AGENDA
CITY OF CEDAR FALLS, IOWA
PLANNING AND ZONING COMMISSION
WEDNESDAY, MARCH 28, 2018
5:30 PM AT CITY HALL - COUNCIL CHAMBERS

TO: Planning & Zoning Commission
FROM: Shane Graham, Planner II
DATE: March 21, 2018
SUBJECT: Holiday Inn & Suites/Conference Center Site Plan Review

REQUEST: Site plan approval for a new 126-room hotel and 31,142 square foot conference center.

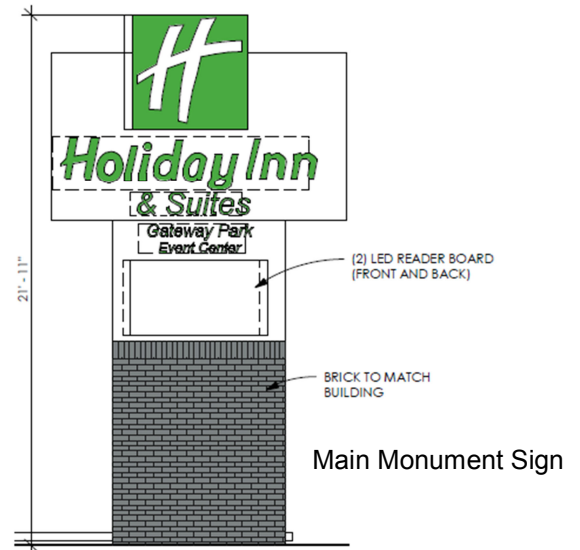
- 8) Trash Dumpster Site: The trash dumpsters will be entirely located within the building, where an overhead door can be opened to allow for emptying the contents. This door to the trash dumpster will be located on the east end of the building, near the middle access from Cyber Lane. **Dumpster enclosure plan is acceptable.**

1 SITE PLAN
1" = 40'

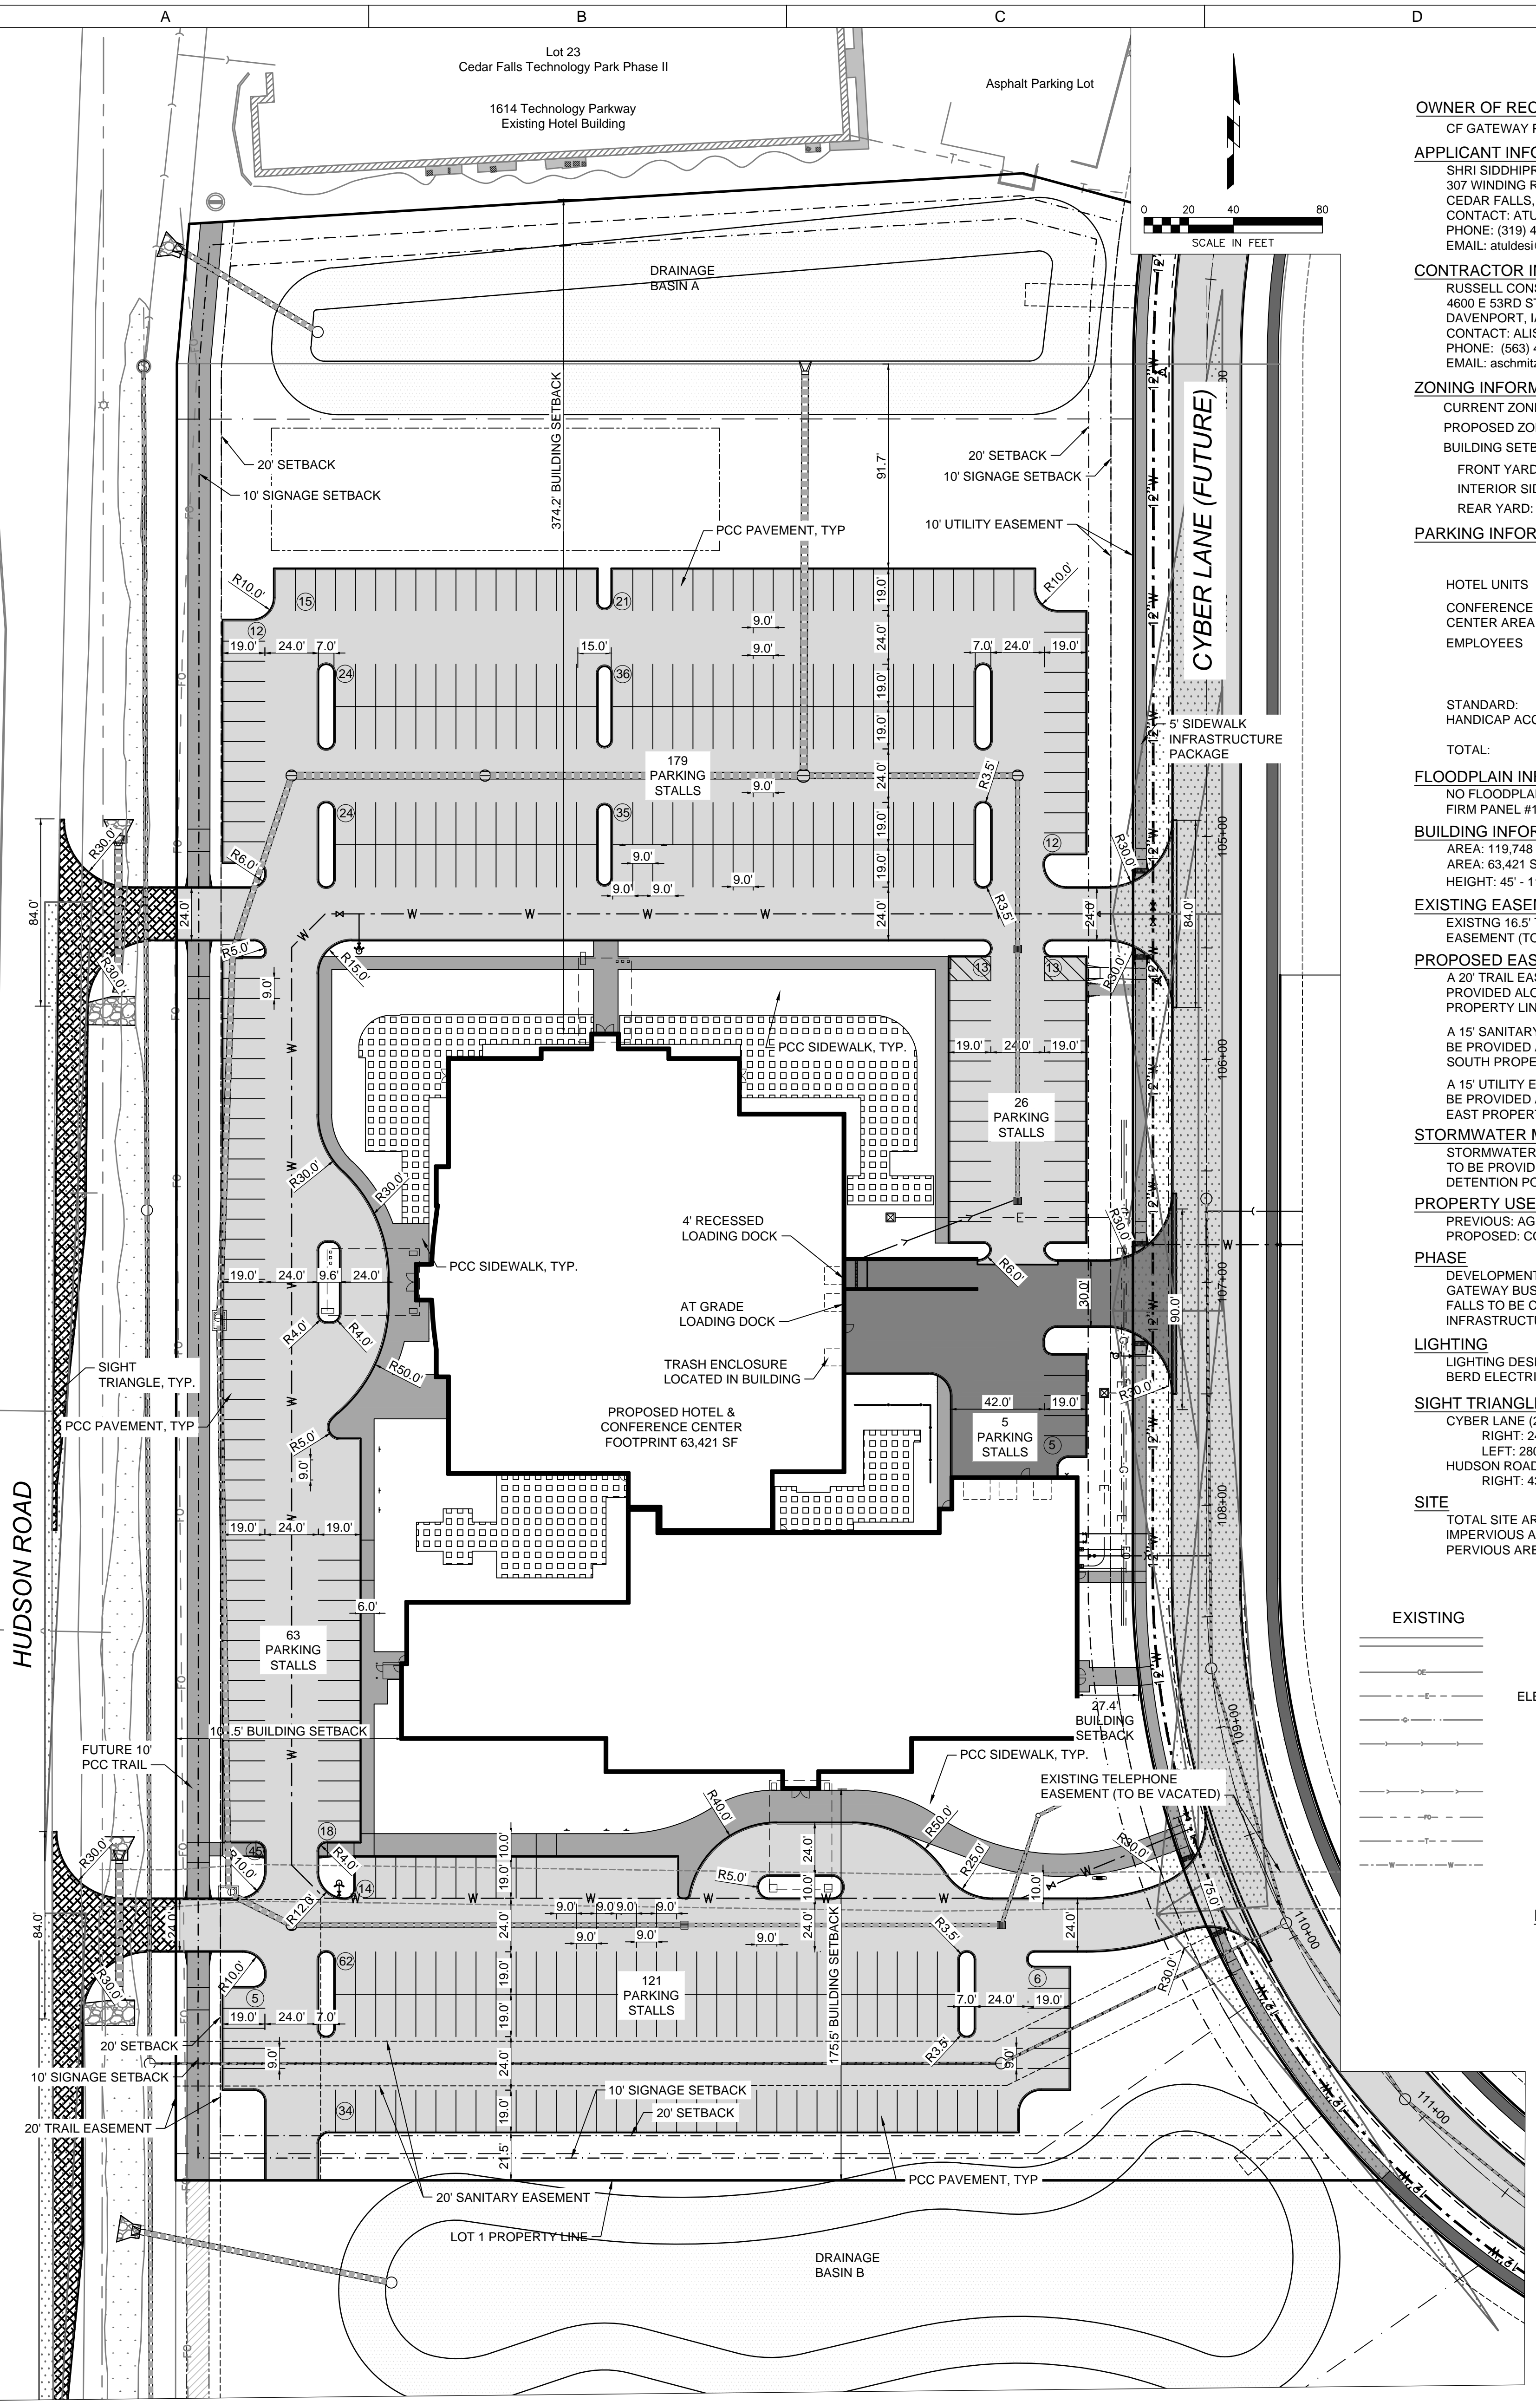
- 3) Parking/Access: A hotel is required to provide 1 parking space for each guest room, plus 1 parking space for every 2 employees. A conference center is required to provide 1 parking space for every 200 square feet of floor area, plus 1 parking space for every 2 employees. Based on the number of rooms in the hotel (126), conference center area (34,310 SF), and employees (90), the site will be required to provide 343 parking spaces. The site plan provided shows 346 parking stalls, which exceeds the required amount by 3 parking spaces.

Also, the site plan shows an additional 76 parking stalls at the north end of the parking lot. These spaces would be utilized for a new hotel at the north end of the site in the future. The north end of the parking lot will have curbing along it where it meets the future parking area. This will prohibit vehicles from driving past the parking area in the grass/open space area until the future parking spaces are constructed.

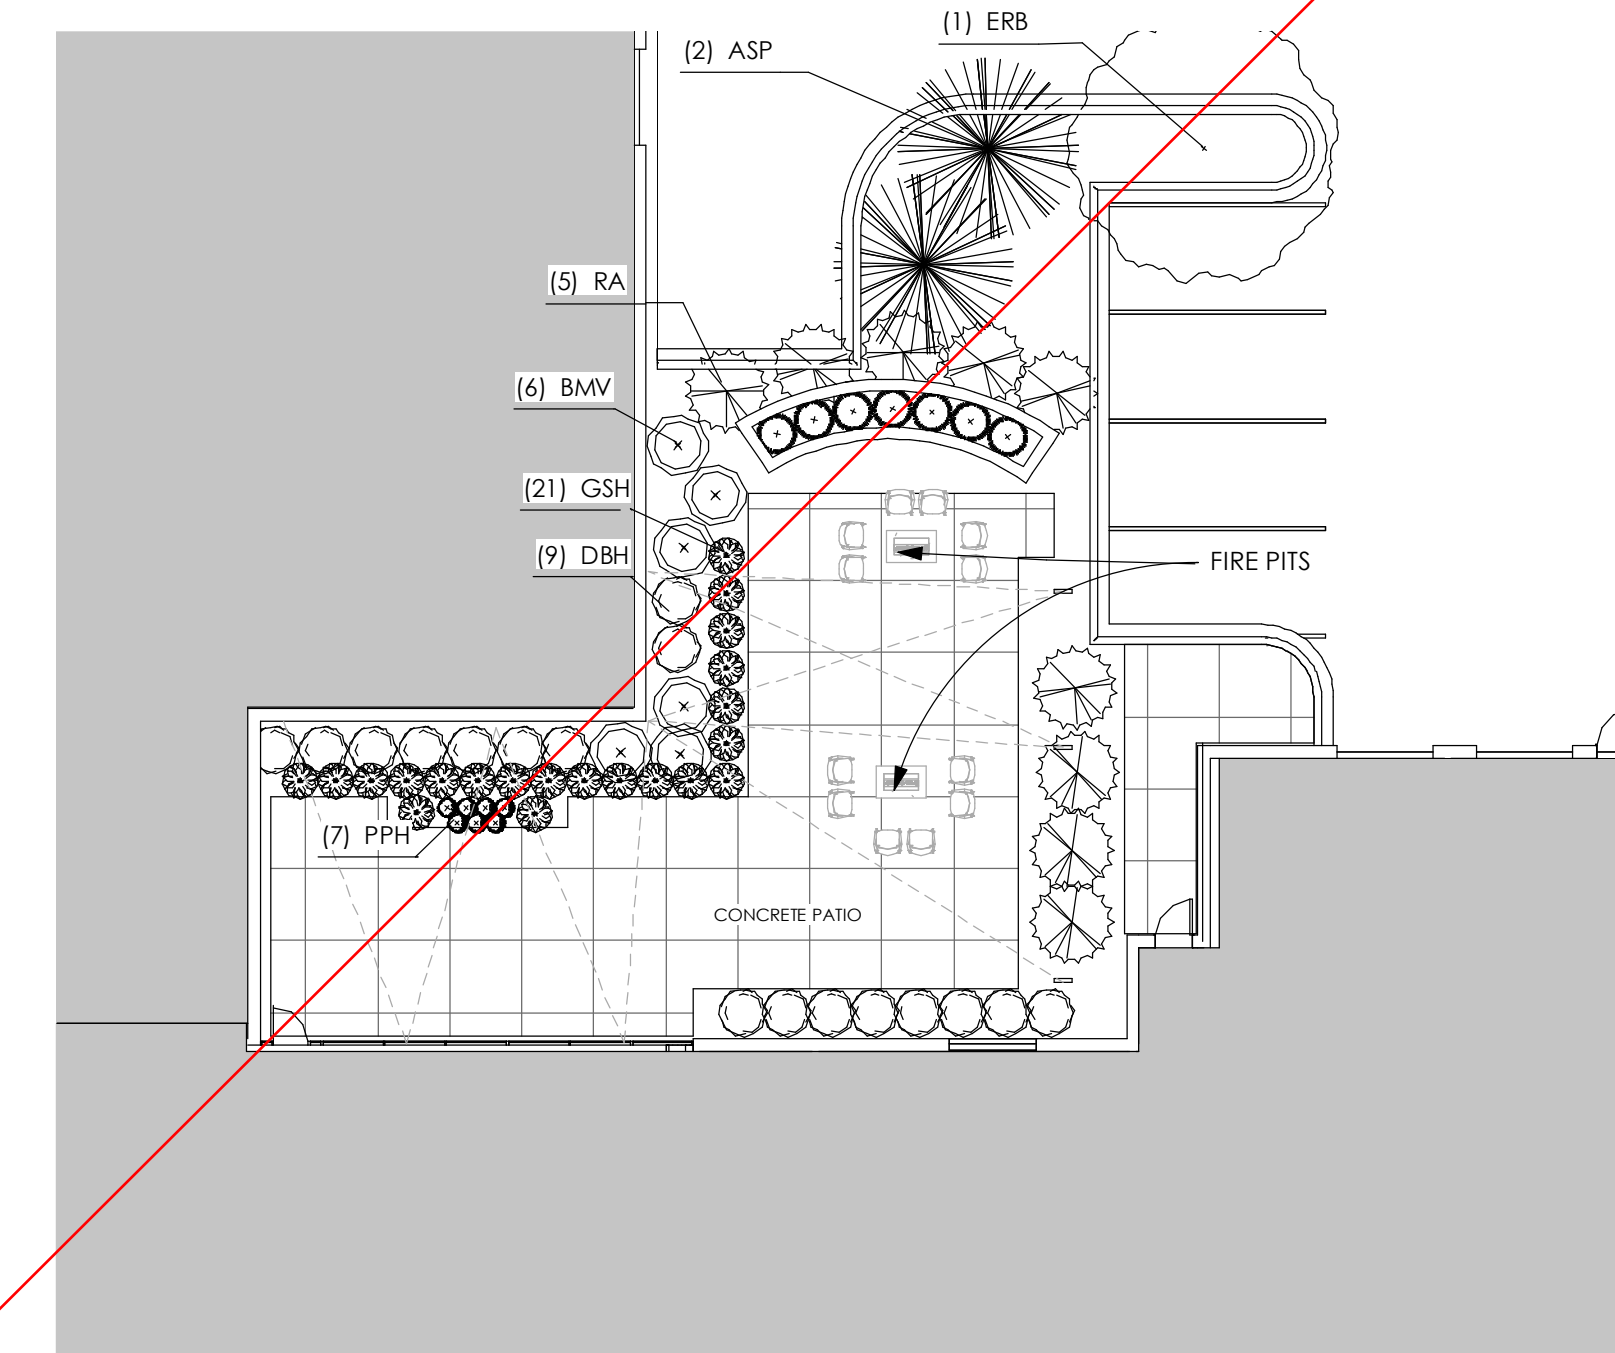
This area is being updated to reflect sheet L1. There will be an increase in the amount of plants and shrubs and an increase in the impervious area by 53 sq. ft.

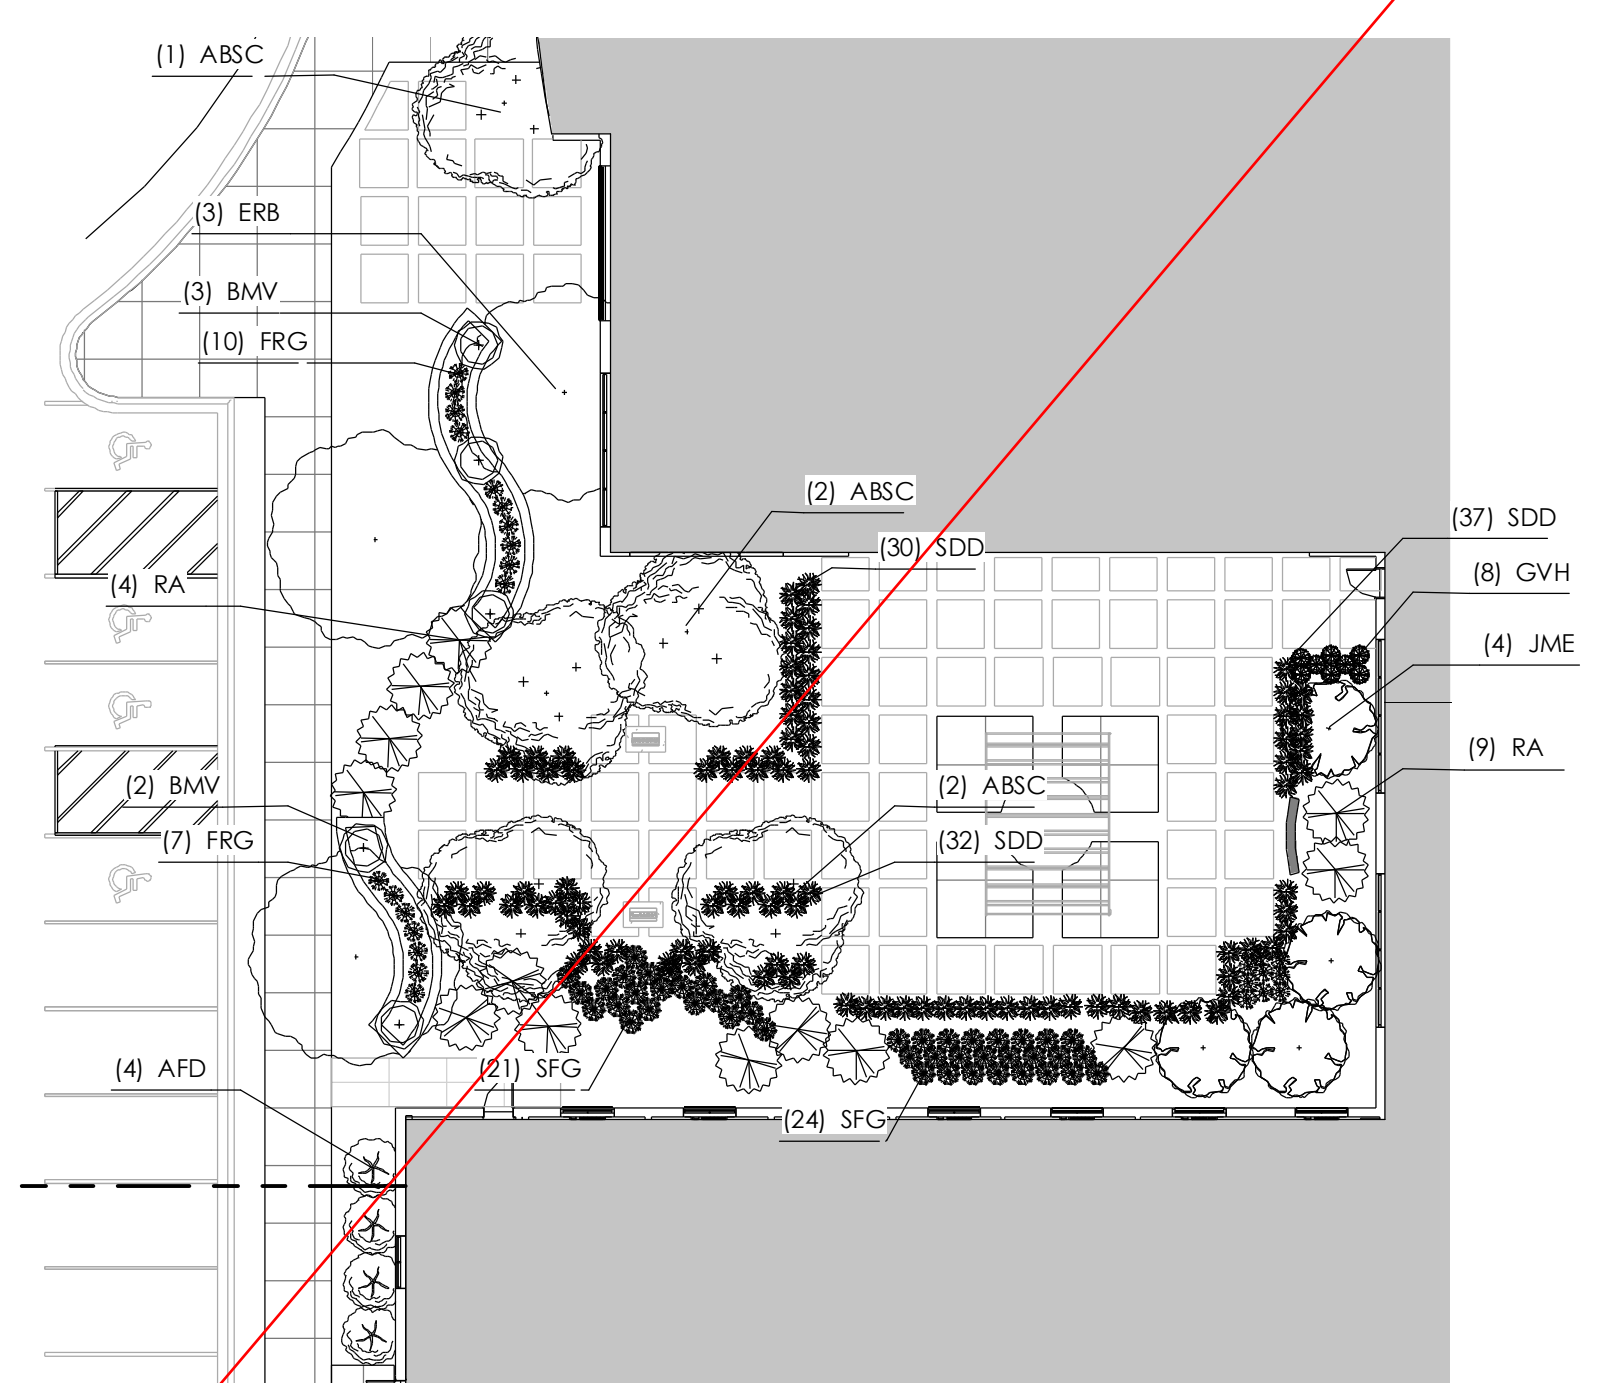
This area is being updated to reflect sheet L1. There will be an increase in the amount of plants, grass, and shrubs and a decrease in impervious area.
